**Planning Proposed Minor Amendments
62-63 Tottenham Court Road, 1-3 Goadge Street**

Revision B

Reference 5315

January 2014

'Proposed' First Floor Layout

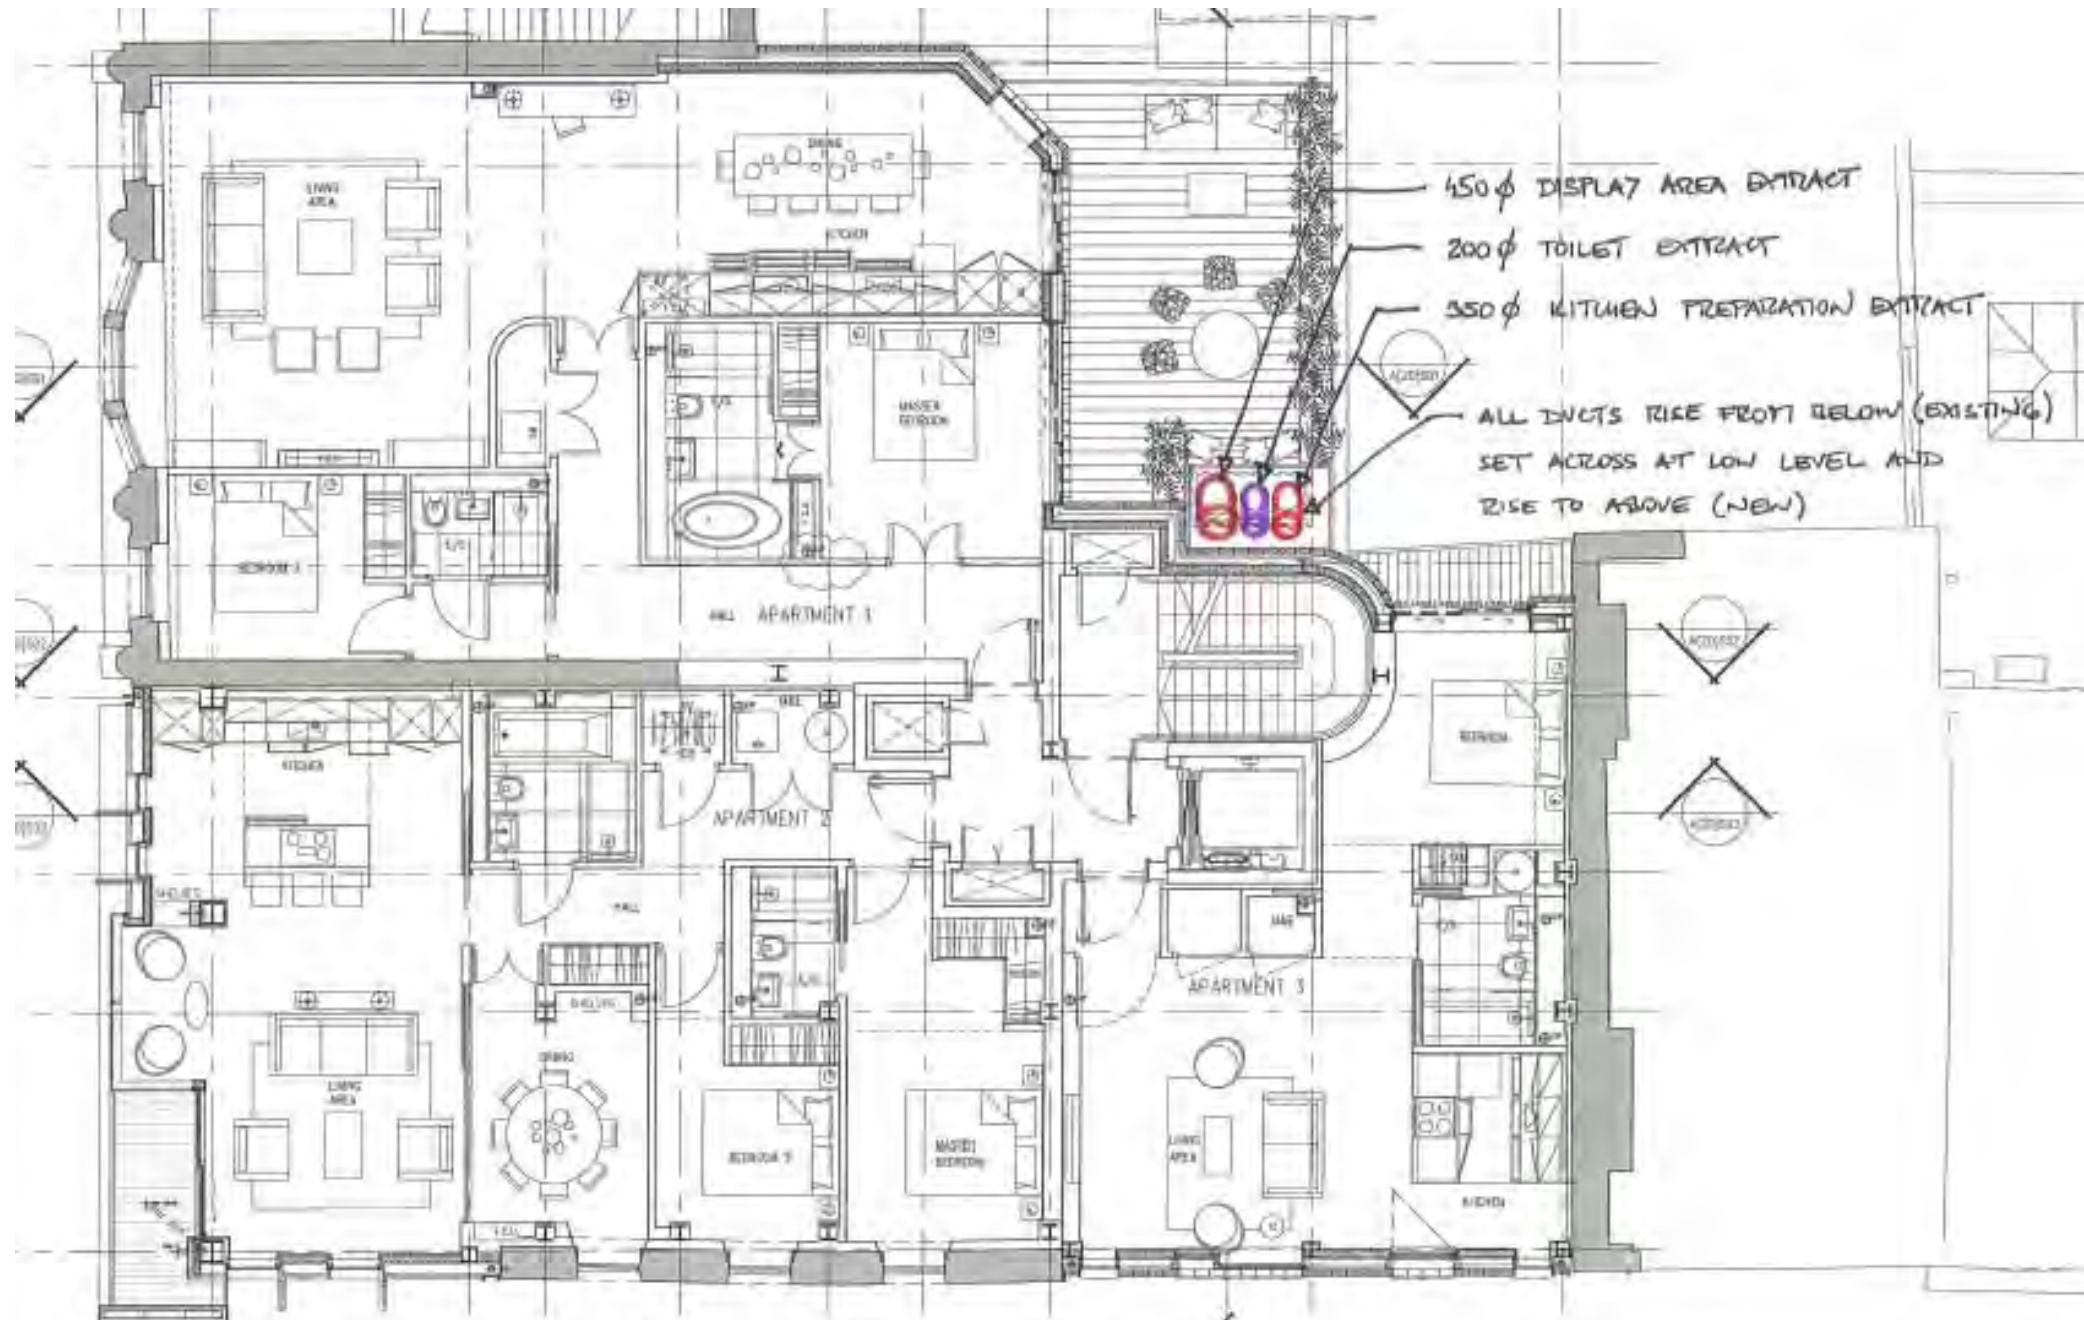
The new residential proposal incorporates a large residential terrace at first floor level where the ducts currently terminate. As all ducts carry foul air from kitchen preparation and toilet areas, the intention is to discharge all three ducts above the new roof level to eliminate the negative impact on the residential development as well as the retailer's need for extensive air treatment of the existing ventilation system.

It is proposed to cut the existing ductwork at first floor level and install new ductwork extending to the new roof level and running externally within an architectural enclosure/cladding. Appropriate access in line with relevant standards will be incorporated into the design of both, the ductwork and its enclosure.

PROPOSED ELEVATION - 1-3 Goodge Street Façade (refer to drawing T20DE01):

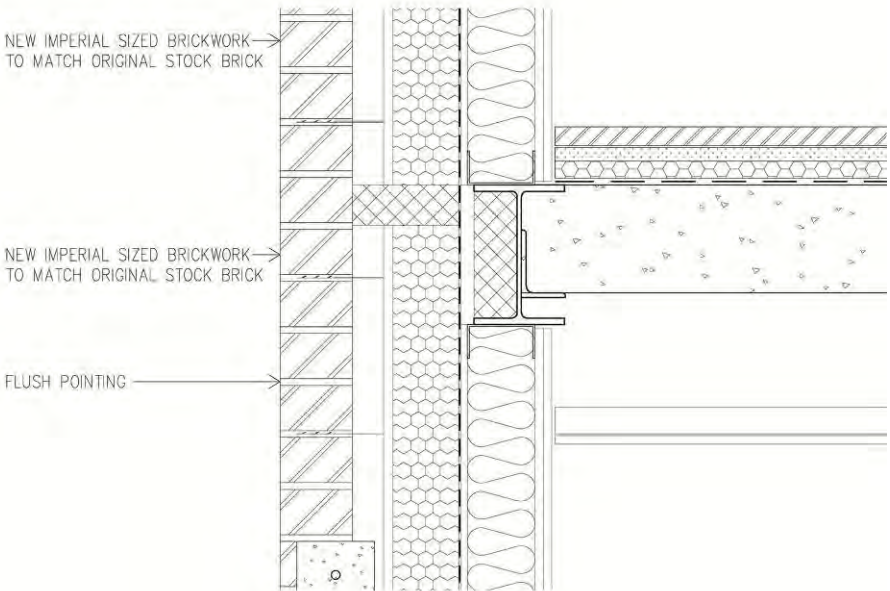
The proposed facade will be constructed using modern methods of construction for the internal walls with the external facade and detailing replicating the original appearance. New or reclaimed imperial sized stock bricks will be laid in Flemish bond with lime mortar, jointing and flush pointing (see proposed elevation and details: 1 & 2). Brick to be agreed with Camden.

DETAIL 3 - Detailed elevation illustrating brick arch and window reveal:

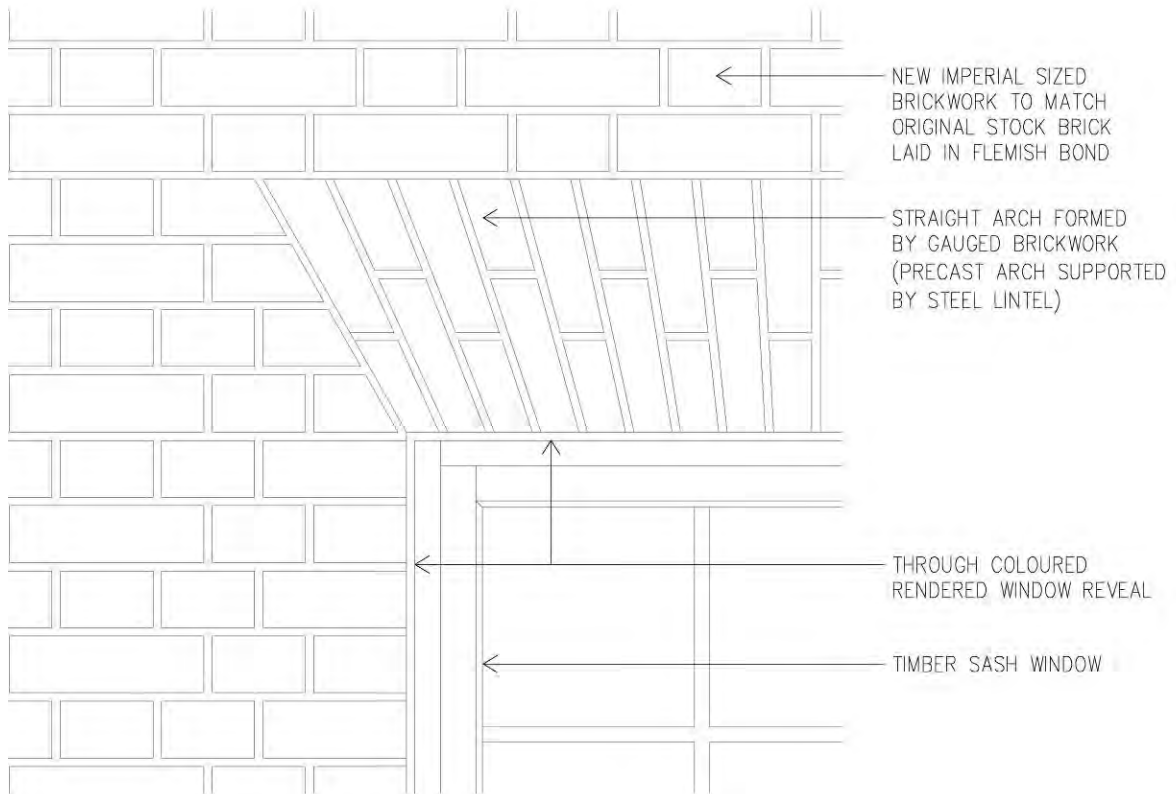
The heads to the nine windows will be straight precast arches formed using gauged brickwork (to match original red brick in contrast to the rest of the façade). They will be supported by steel lintels or brick support angles (see proposed details: 3 & 4).

DETAIL 5 - Typical window jamb detail:

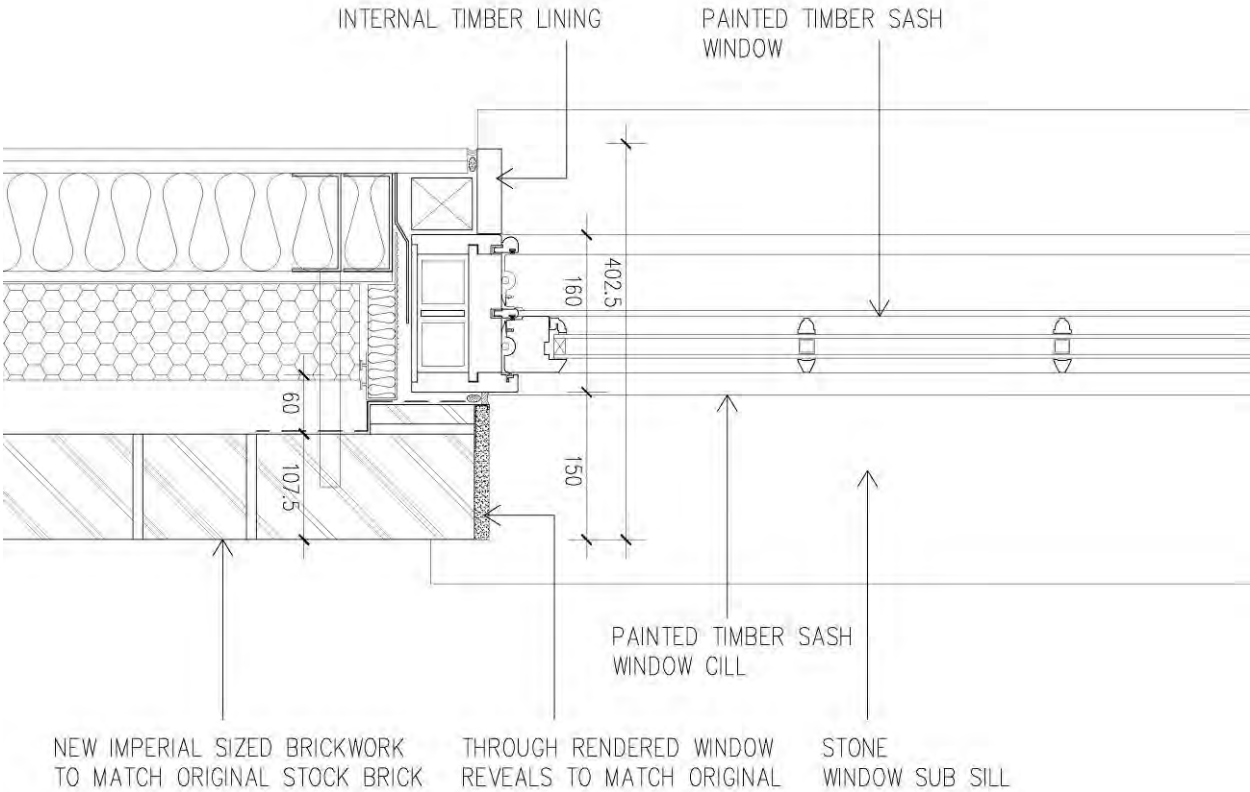
The reveals to the windows will be through coloured render (see proposed detail 5).

DETAIL 6 - Typical window jamb detail:

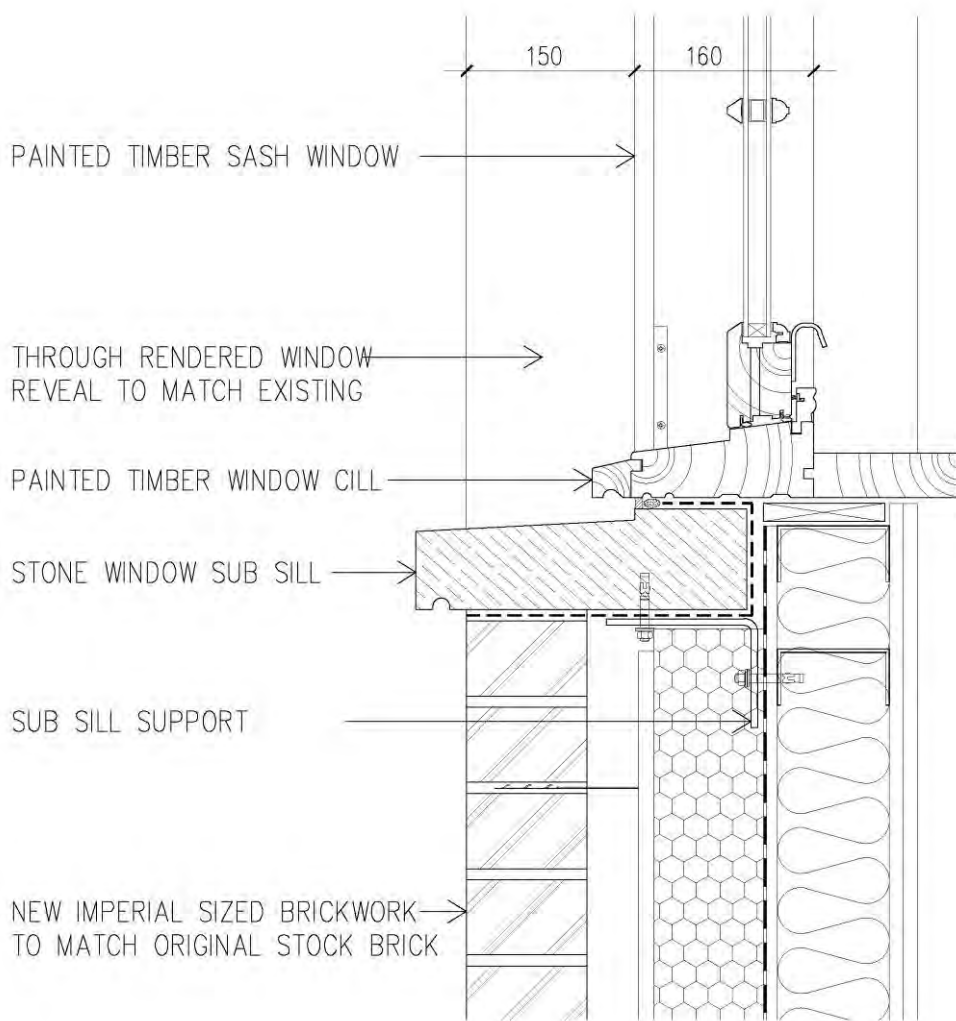
The sub sills to the nine windows will be made of natural stone or reconstituted concrete (see proposed detail 6).

DETAIL 7 - Typical wall coping detail:

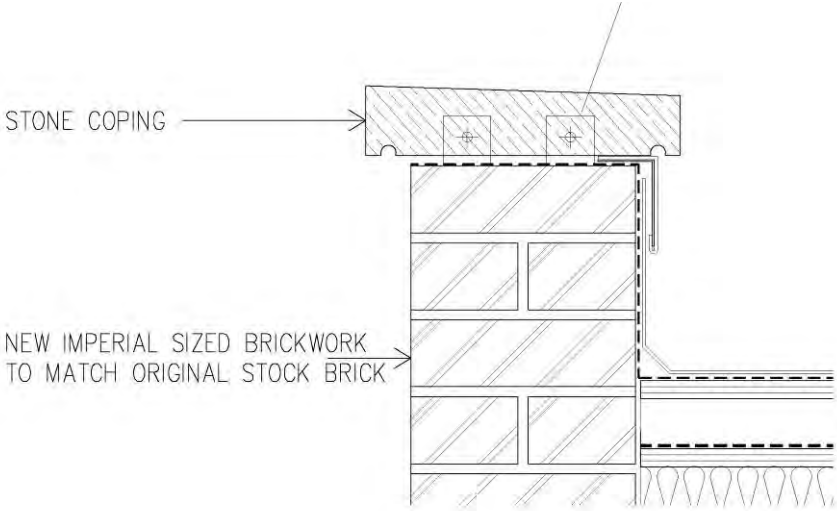
Coping to the brick wall will be made of natural stone or reconstituted stone

DETAIL 8 - Cornice detail:

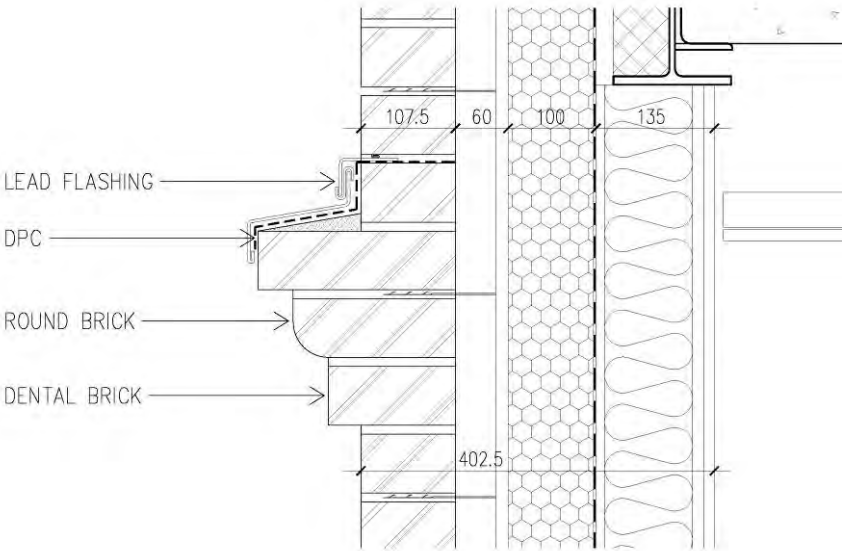
Cornice between 3rd and 4th floor will be made of three courses of brick (size and colour same as facade - see proposed detail 8).

DETAIL 9 - Detailed elevation of timber sash window:

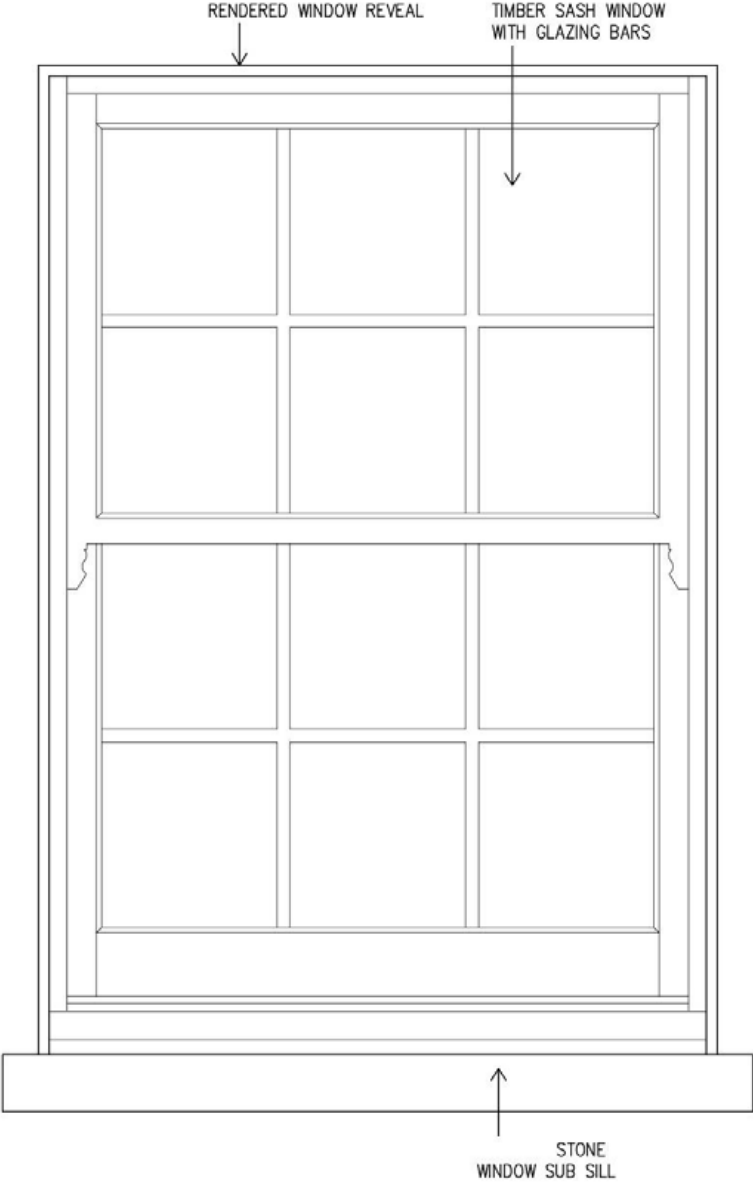
All nine windows will be timber box sash windows with glazing bar division (see: proposed detail 9)

PROPOSED SHOP FRONT PLAN:

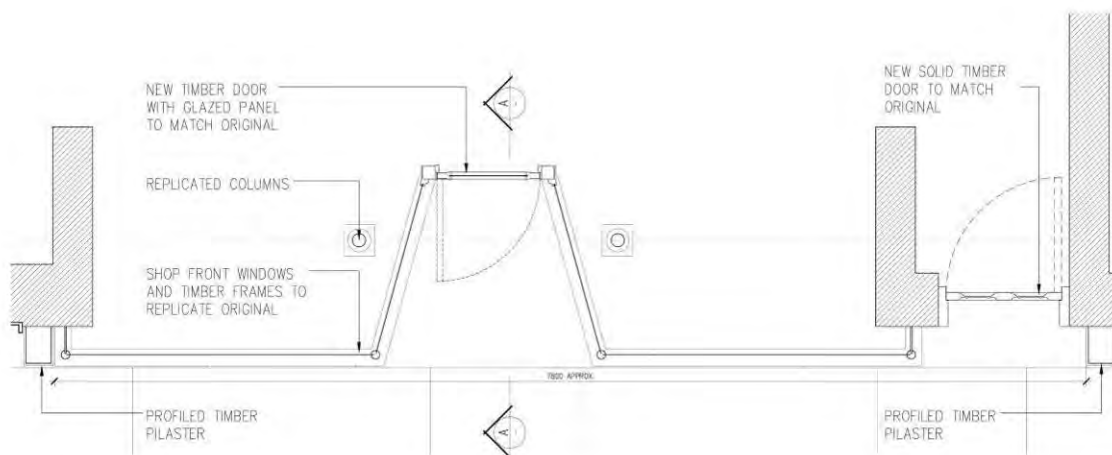
The proposal is to rebuild the shop front to replicate the Victorian frontage. The frontage will reinstate the missing elements of the shopfront eroded over time.

A new timber shopfront will be installed. Decorative console brackets to match the original will form the top of new pilasters to either side of the frontage. The entablature will be recreated with a defined cornice, correctly proportioned sloped timber fascia.

Timber window mullions together with decorative capping to match the original will be installed above a simple panelled stall riser. The recessed entrance and timber glazed door with glazed panel above will be installed with sloped glazed panels either side. *(It should be noted that whilst this matched the original, Camden Council have previously asked for the recess to be boarded up due to problems with rough sleepers. Our client is happy to consider an in line entrance if deemed appropriate.)*

A new timber panelled door with glass fanlight above will be installed to the right of the main shop front.
